**Monks Orchard Residents' Association
Planning**

Stage 1 Complaint – Planning Approval Ref: 19/01352/FUL - 56 Woodmere Avenue, Croydon, CR0 7PD.

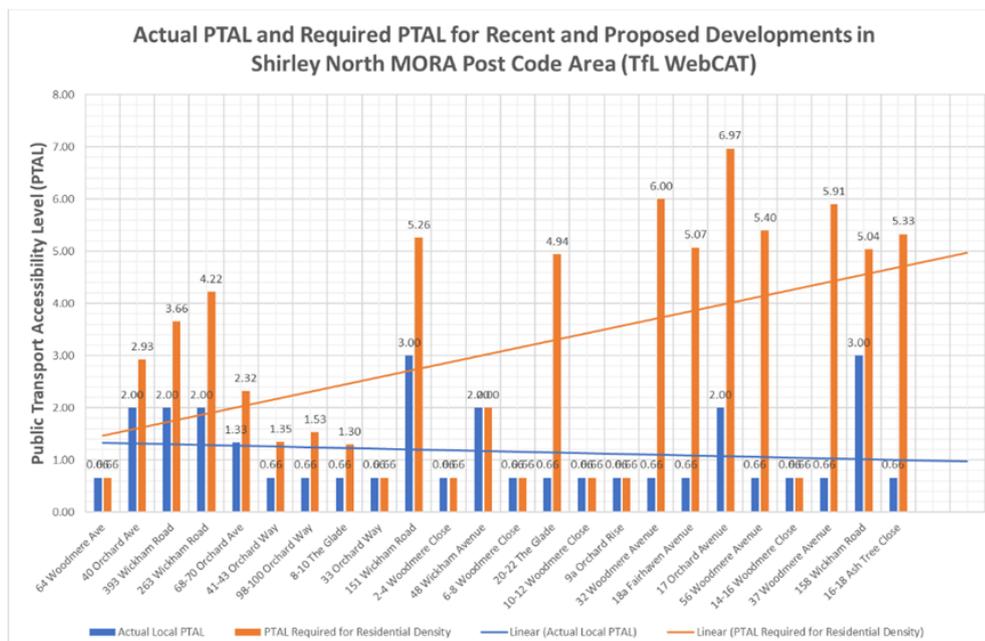
The Histogram above illustrates the **excessive Residential Densities** of recent developments within the MORA Post Code Area required PTAL against the available and forecast PTAL.

The cumulative increase in Residential Density (i.e. Population increase) should meet the planned Public Transport availability (see Histogram above).

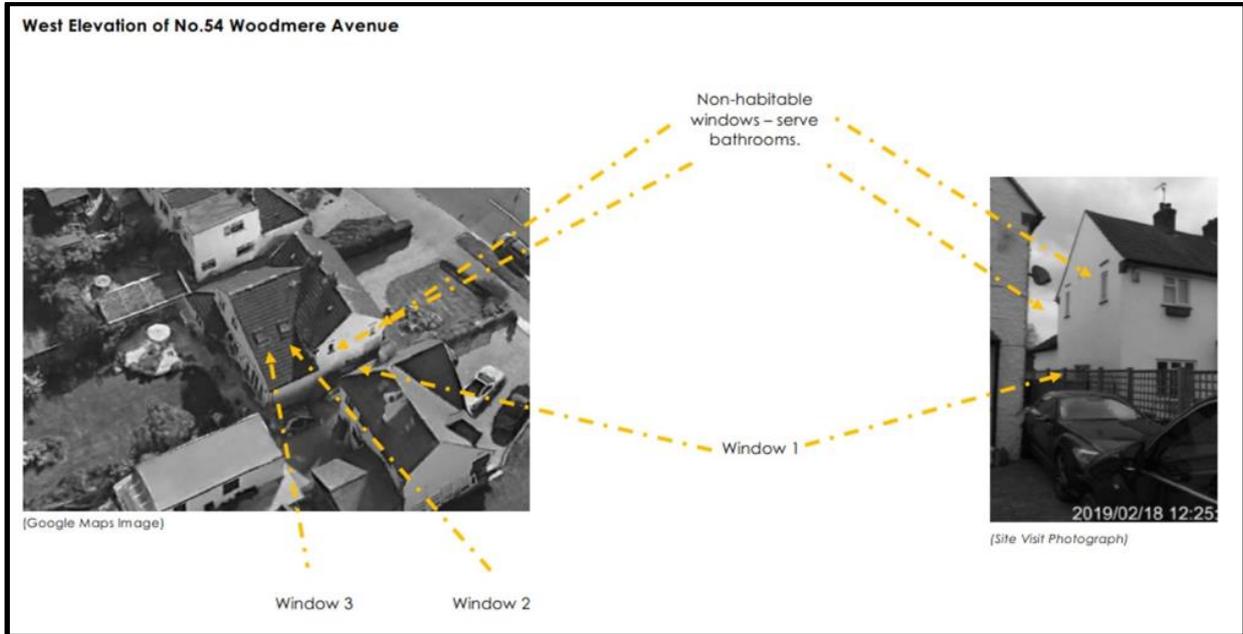
There was **NO** quoted justification based upon “orientation”, “topography”, “landscaping” or “neighbouring land uses” to allow relaxation of the Policy and **NONE** were identified as reasons for relaxing the requirement of the 45 Degree (Vertical) Policy, There were **NO** “exceptional circumstances” for scope for an intercept beyond the 45° vertical projection. In fact, the proposal was to be sunk in the ground by approximately 0.6m otherwise the projected intersection would be even more significant.

Applicant's Assessment

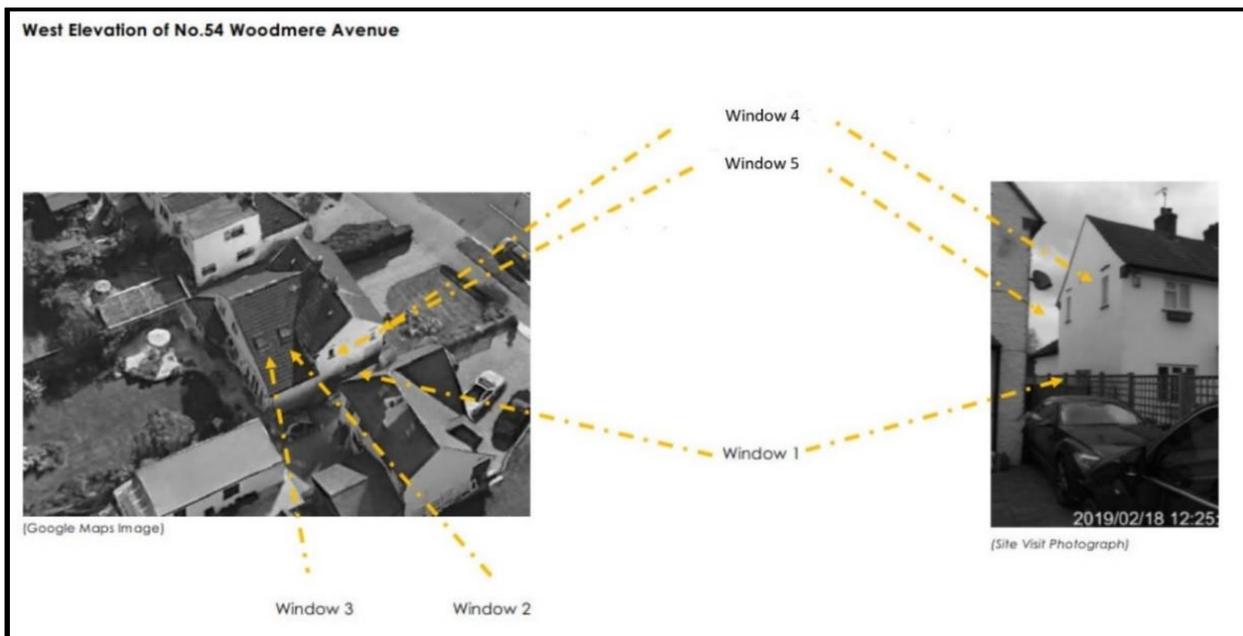
From the foregoing, only **Windows 2 & 3** Serve **Non-Habitable Rooms** (Bathrooms) and these are Velux roof windows. **All other windows serve Habitable Rooms** and thus require **natural daylight** as defined in **BR209** and **SPD2 para 2.11.2**. The Applicant's assessment that **Windows 4 & 5 served non-habitable rooms of 54 Woodmere Avenue was incorrect and therefore the effect and Daylight Assessment was Flawed.**

It is understood that the Applicant's assessment of BR209 was incorrect and that the **Case Officer did not challenge or correct this misunderstanding** of the effects of restricted daylight to the **habitable rooms of 54 Woodmere Avenue.**
